Item Name: Crosstube Assembly, Mid Fwd

DART AEROSPACE LTD	Work Order:	95448
Description: Crosstube Assembly, Mid Fwd	Part Number:	D206-667-147TRN
Inspection Dwg: D206-667-147 Rev: A		Page 1 of 2

DRAWING NO. D206-667-147	TITLE CROSSTUBE ASS'Y (206L MID FWD)	REV. A	DART AEROSPACE LTD ENGINEERING ORDER		D.E.O. NO. D206-667-147-A-1	SHEET NO. SHEET 1 OF 1	SCALE NTS
DRAWN <i>qp</i>	CHECKED <i>AS</i>	MFG. APPR. <i>AS</i>	APPROVED <i>MD</i>	DE APPR. <i>MD</i>			
DATE 11.07.15	DATE 11.07.20	DATE 11.07.21	DATE 11.07.21	DATE 11.07.21

DRAWING NO. D206-667-147		TITLE CROSSTUBE ASS'Y (206L MID FWD)		REV. A		DART AEROSPACE LTD ENGINEERING ORDER		D.E.O. NO. D206-667-147-A-2		SHEET NO. SHEET 1 OF 1		SCALE NTS	
DRAWN AJS		CHECKED		MFG. APPR.		APPROVED		DE APPR.		DATE		DATE	
DATE 12.08.02		DATE 12.08.02		DATE 12.08.02		DATE 12.08.02		DATE 12.08.02		DATE 12.08.02		DATE 12.08.02

DETAIL P
BONDING STRAP INSTALLATION 2 PL

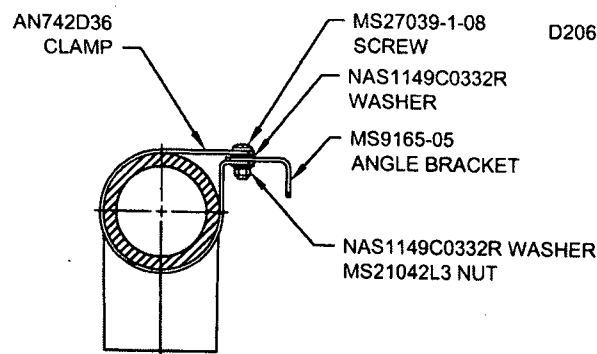
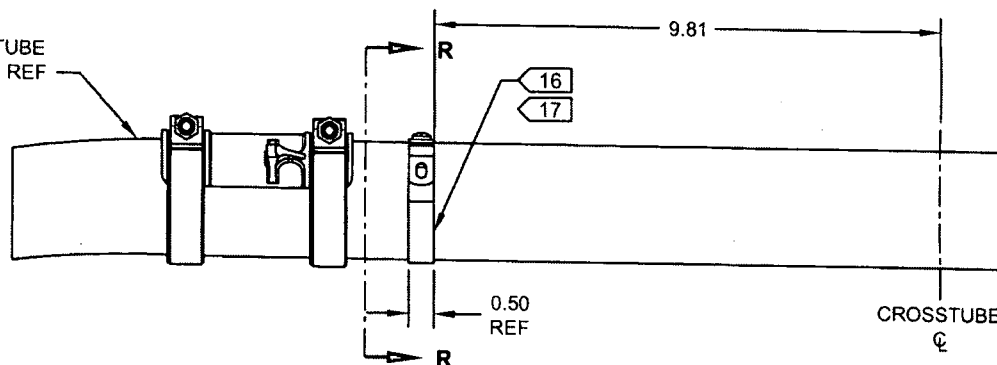
ADD ELECTRICAL GROUNDING STRAP

- 16) MASK AREA UNDER CLAMP PRIOR TO PAINTING
- 17) SEAL EDGES WHERE AN742D36 CLAMP MEETS WITH THE CROSSTUBE USING SIKAFLEX-241/-291 OR MIL-S-8802 CLASS B2 OR PROSEAL 890 SEALANT
- 18) PERFORM RESISTANCE CHECK TO ENSURE MAX RESISTANCE IS 10 MILLIOHMS
